**Upper Main Eel Temperature and Sediment TMDLs
Comment Responsiveness Summary
December 28, 2004**

2004 Pool/riffle above Tomki

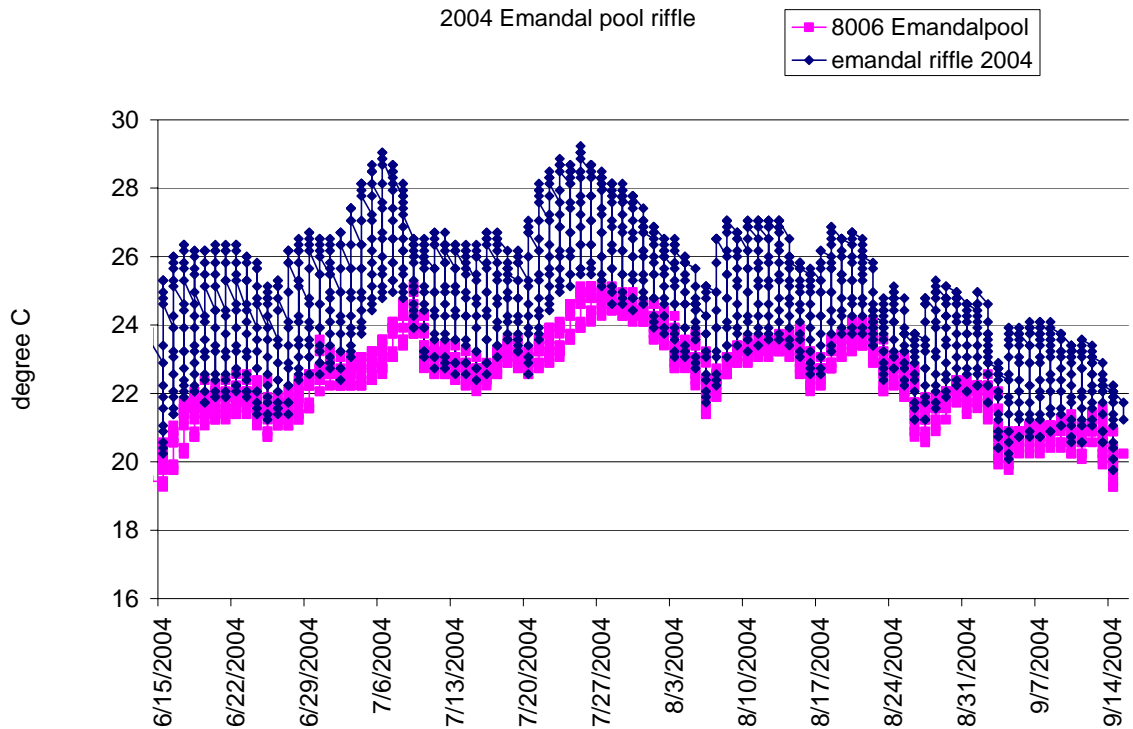
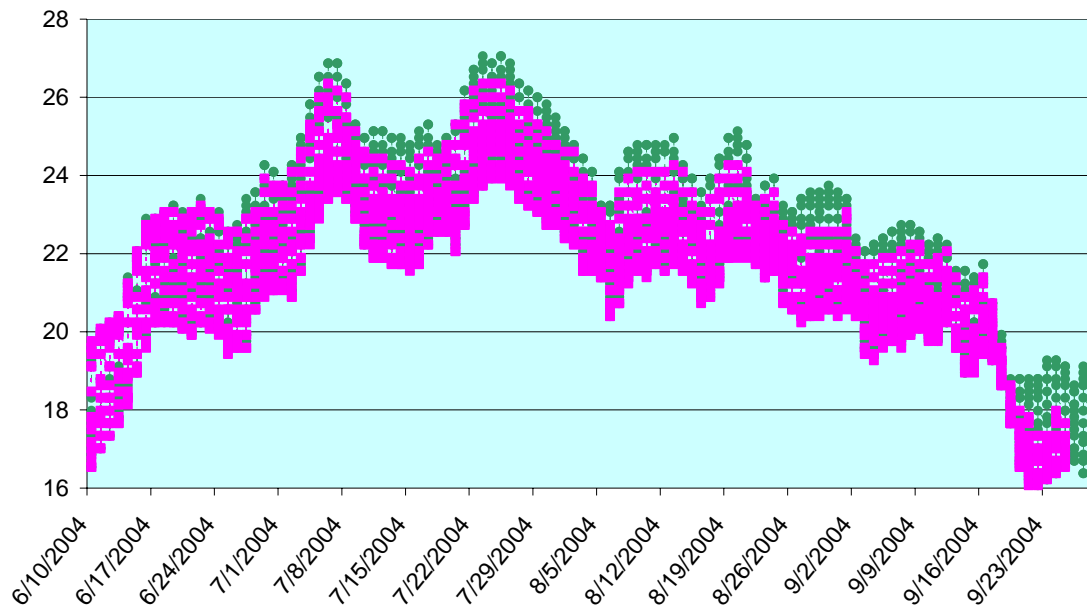
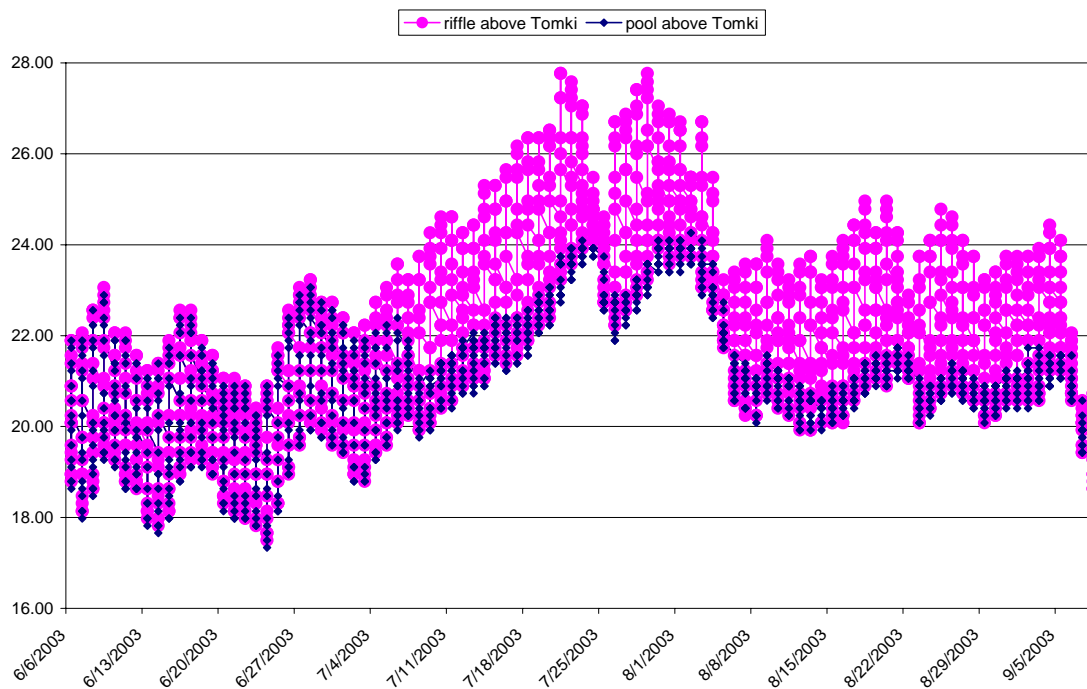
Comment 2-15: "Explain how this model handles temperature stratification in deep pools and state model assumptions and the inherited limitations. Sensitivity tests should be conducted to determine important parameters in the context of the uncertainty relative to the modeling accuracy."

Response: The stream temperature model does not account for how increases in flow influence the temperature stratification in deep pools. The 2004 temperature monitoring data by DFG provides information on 2 pool riffle combinations near Tomki Creek and one pool/riffle combination near Emandal. One pool continued to stratify and one pool did not stratify. Specifically, data from 2004 for the pool riffle combination near Emandal indicates that this pool continues stratifying even under the 15 cfs summer flow. This same pool and riffle was also monitored in previous years. Graphs 1 – 3 illustrate the temperature patterns during 2002 - 2004. This data is preliminary, specifically, the temperatures at Van Arsdale were unusually warm (>24 °C) during much of July. Thus this information should be considered preliminary as it was an unusual pattern.

However, the 2004 data from one pool riffle complex near Tomki Creek indicate that the pool did not stratify. In the previous years the pool stratified for much of the summer. This lack of stratification could be due to the increased flow from the Potter Valley Project and is a loss in refugia for summering steelhead. During 2004 data from the other pool/riffle complex was not available due to the loss of one monitor. Results from future monitoring under increased flow conditions would assist in determining how widespread and common this loss of stratification is in the area. EPA recommends that PG&E increase the monitoring of pool riffle combinations over time. Monitoring of additional pool riffles is important given the mixed results of the 2004 data. Monitoring in this stretch of the Eel River needs to account for the yearly loss of monitors.
